D206-642-341BL
Job Sheet 167820-K

Part Name: Replacement Skidtube (Fits LH or RH)

DRAWING NO. D2650	TITLE 206/407 SKIDTUBE ASSEMBLIES	REV. F	DART AEROSPACE LTD ENGINEERING ORDER		D.E.O. NO. D2650-F-1	SHEET NO. SHEET 1 OF 1	SCALE NTS
DRAWN <i>[Signature]</i>	CHECKED A.P.	MFG. APPR. <i>[Signature]</i>	APPROVED <i>[Signature]</i>		DE APPR. <i>[Signature]</i>		
DATE 12.10.12	DATE 12.10.22	DATE 12.10.22	DATE 12.10.22		DATE 12.10.22

CHANGE C'BORED WELDED CROSSBOLT SPACERS TO SWAGED SPACERS

AMENDMENT TO DETAIL B
NOT TO SCALE

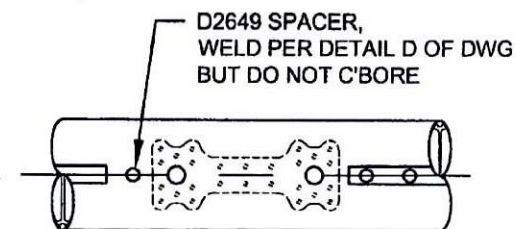
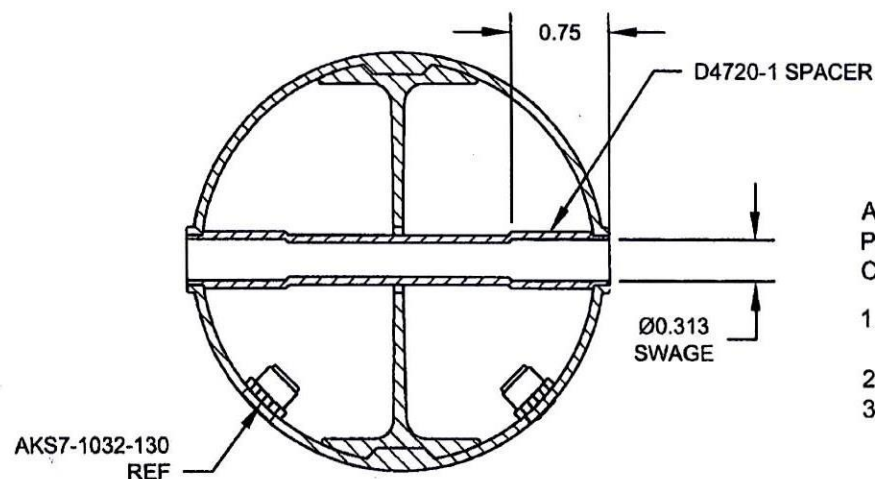
ADD DETAIL G BELOW, WHICH IS THE SAME SECTION VIEW AS DETAIL D OF DWG.

C'BORED HOLES ARE **NOW SWAGED** PER DETAIL G BELOW. FOR THE Ø0.375 HOLE THAT IS NOT C'BORED, WELD PER DETAIL D OF DWG (SEE AMENDED DETAIL B FOR REFERENCE).

AFTER DRILLING AND BENDING ASSEMBLY
PERFORM THE FOLLOWING FOR Ø0.375 HOLES THAT ARE
CURRENTLY C'BORED:

1. INSERT D4720-1 SPACER, 16 PL (-1) OR 17 PL (-3)
OR 19 PL (-5) OR 23 PL (-7)
2. SWAGE TO Ø0.313 X 0.75 DP PER QSI 002
3. TRIM / GRIND FLUSH PER QSI 002
